20190071.3/0307A/R0/GC

Zhiva Living Dural Pty Ltd ATF The Zhiva Living Dural Trust

3 Quarry Road and 4 Vineys Road, Dural - Amended Site Compatibility Certificate Application - Acoustics

Figure 4 – Location of Barrier

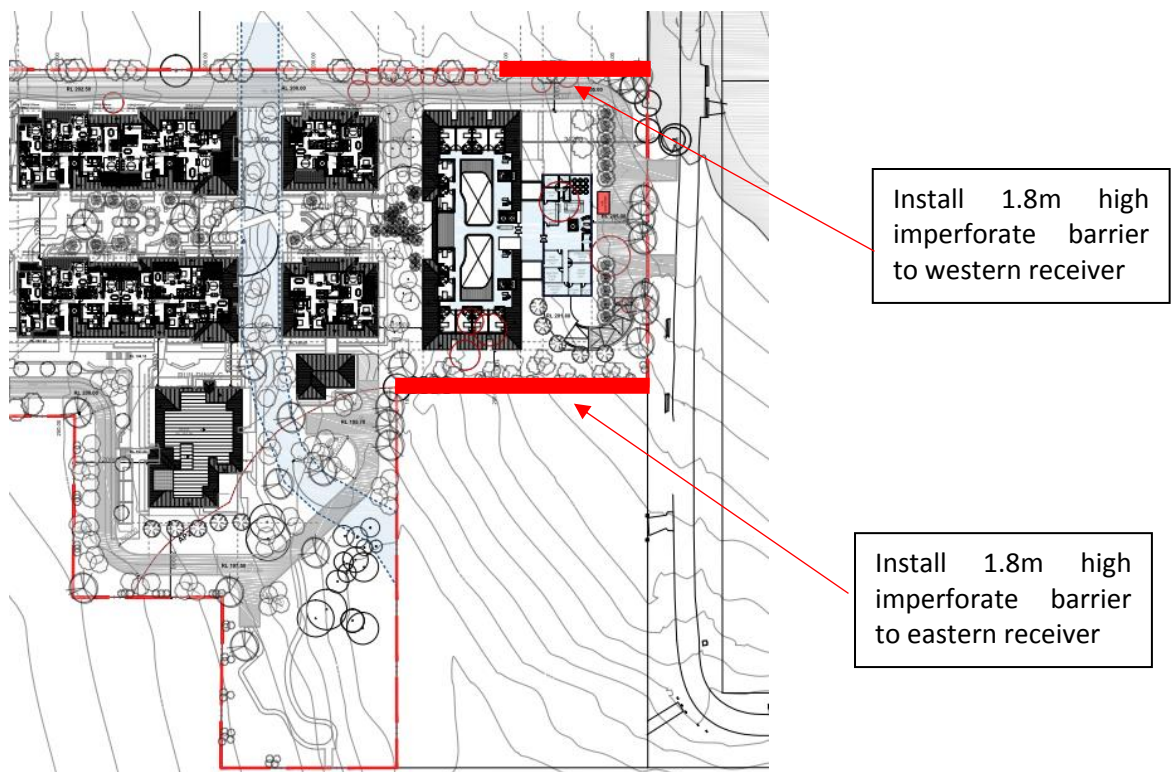
s)	NIA Section 6.2.3.2 refers to a 2 metre barrier on the eastern boundary between the closest residential receivers on Vineys Road. NIA (Section 6.3) Recommends a 1.8m fence on parts of the eastern and western boundaries. NIA provides no modelling to support the recommendations.	ALC Response: The current design shows 1.8 metre high fence based on car park entry assessment.	Agreed

- Loading dock shall be used during day time only.
- Install 1.8 metre fence on the western boundary between the Aged Care Facility and the closest residential receiver on Vineys Road. The fence can be constructed by colorbond or equal with all penetrations and junctions acoustically sealed. (maximum 50mm gap at the bottom of the fence to allow water flow). See figure 4 below for location.
- Install imperforate barrier to be constructed along eastern boundary between the Aged Care Facility and the closest residential receiver. Barrier shall be minimum 1.8 high from natural ground, the structure of fence can be lapped and capped timber or colorbond or equal. See figure 4 below for location.

WINDOWS OPEN / WINDOWS CLOSED - MARK UP

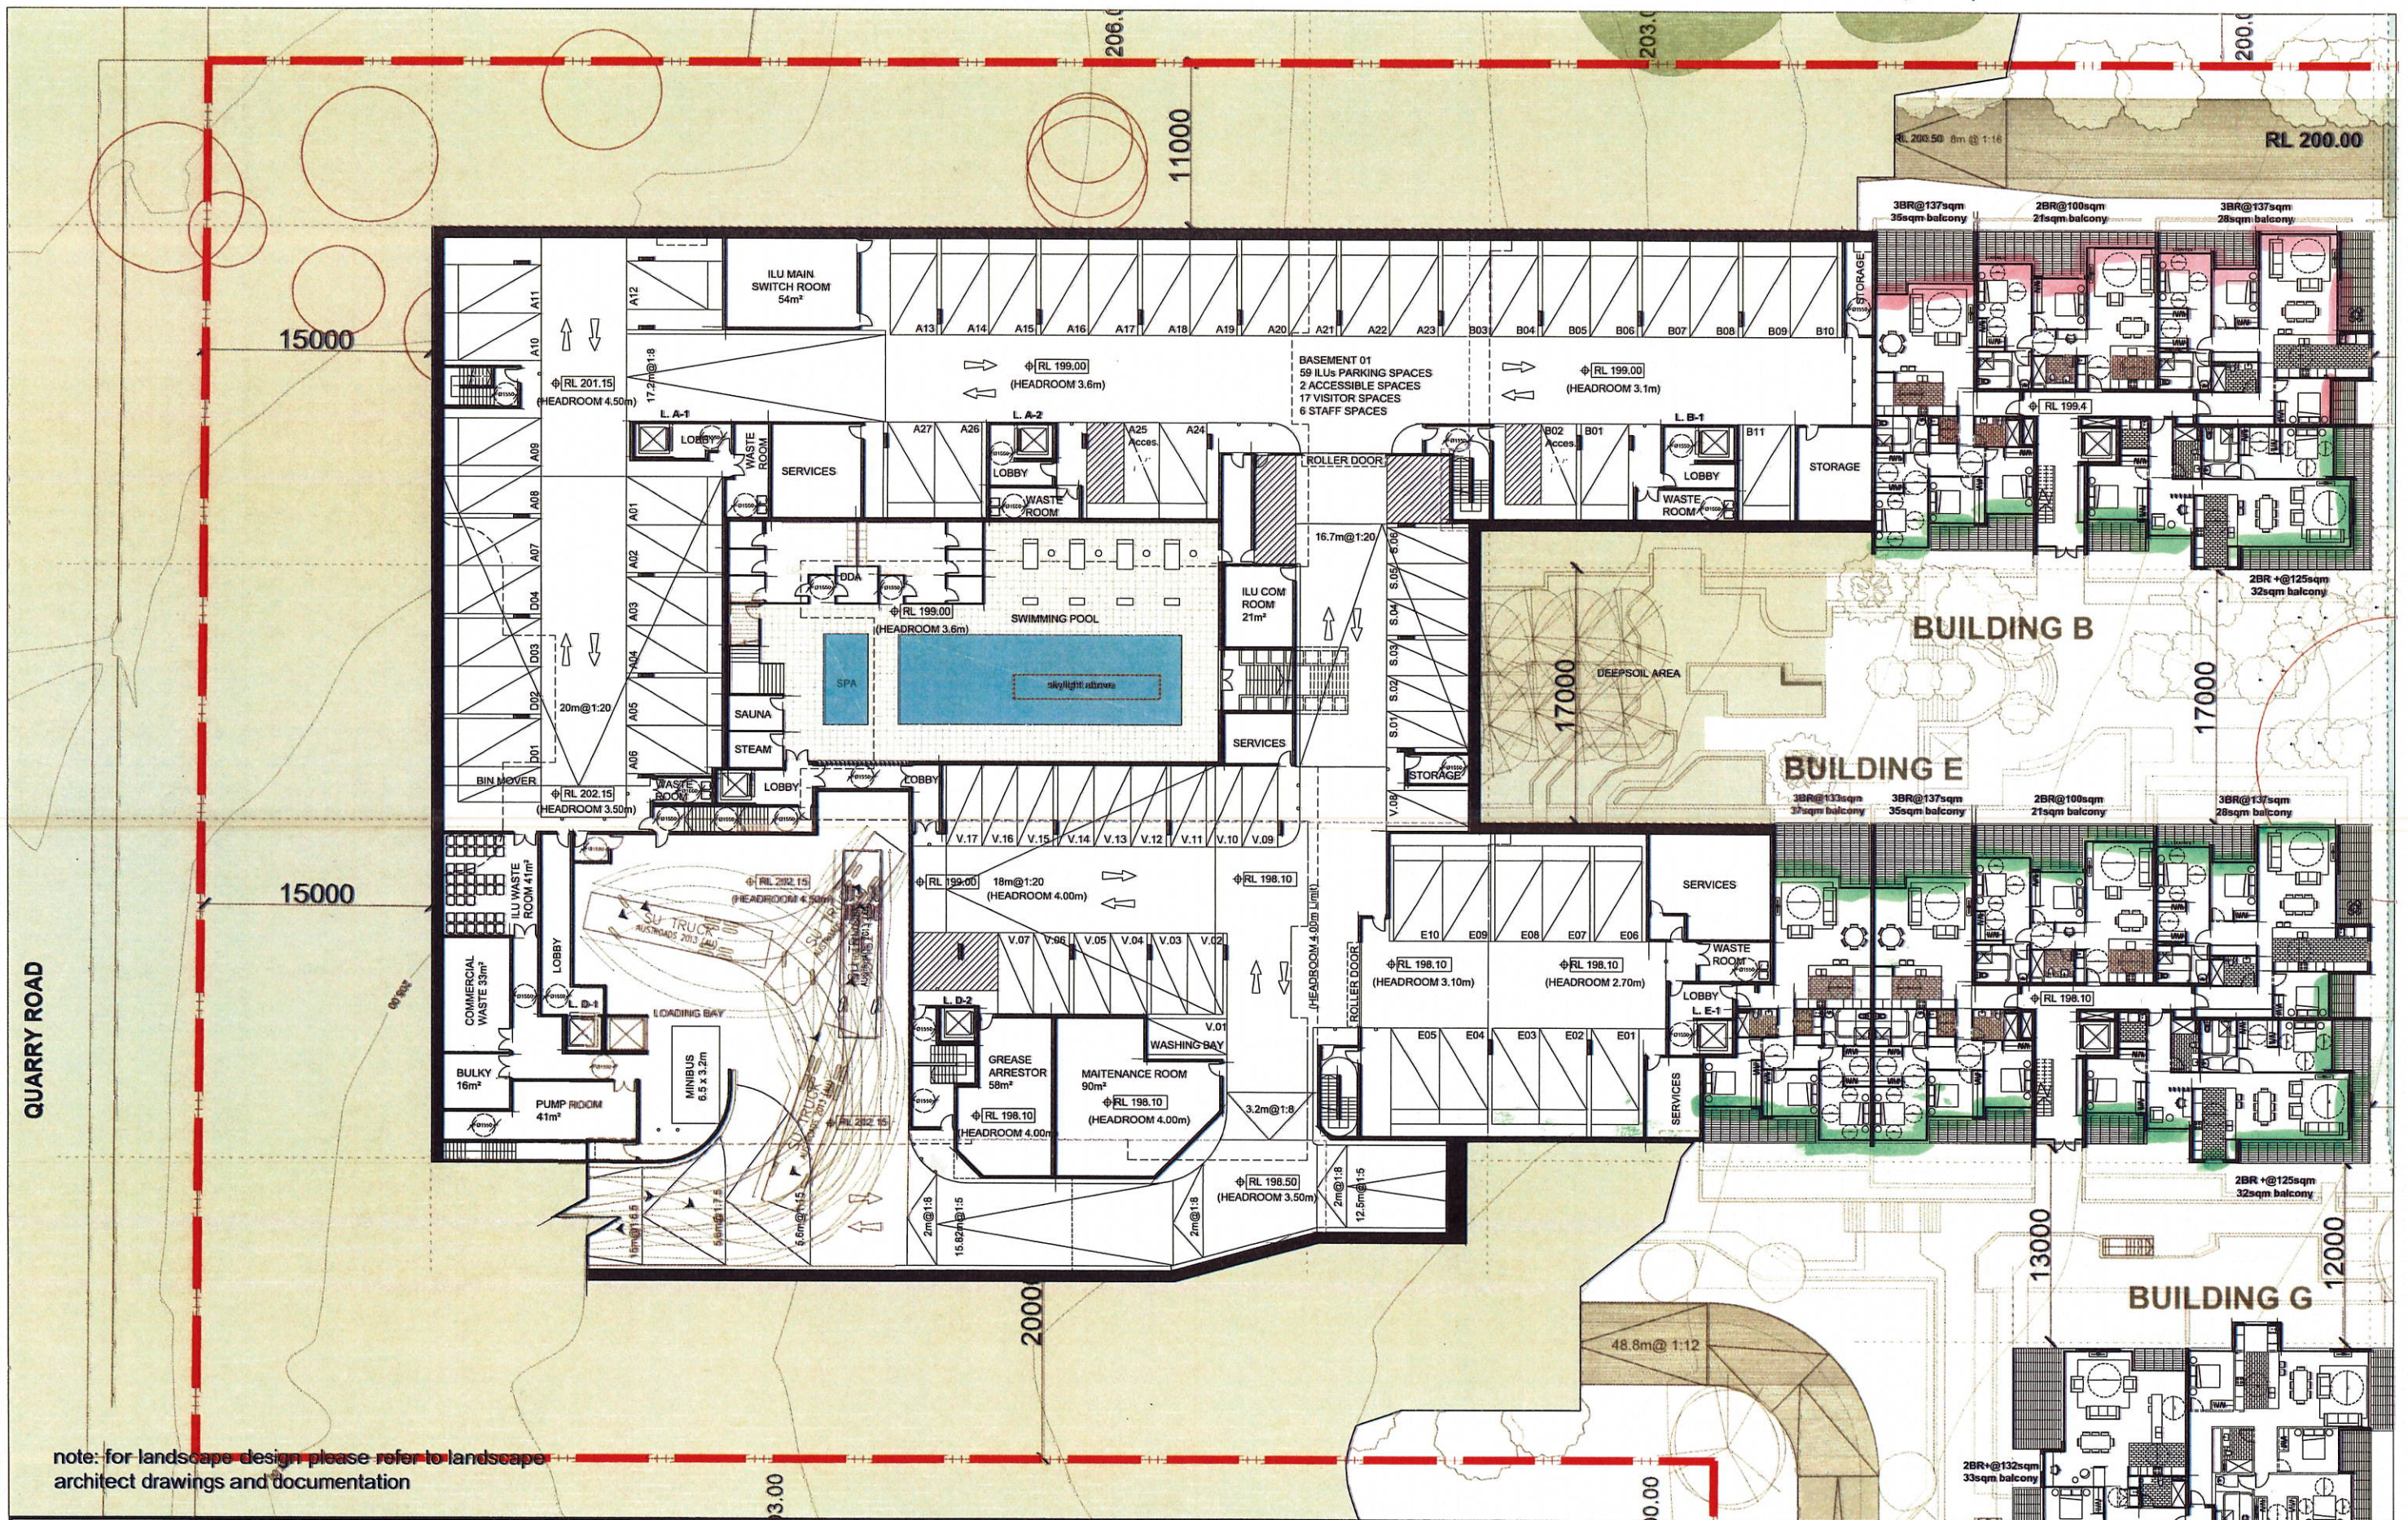
Note: All remaining facades will comply
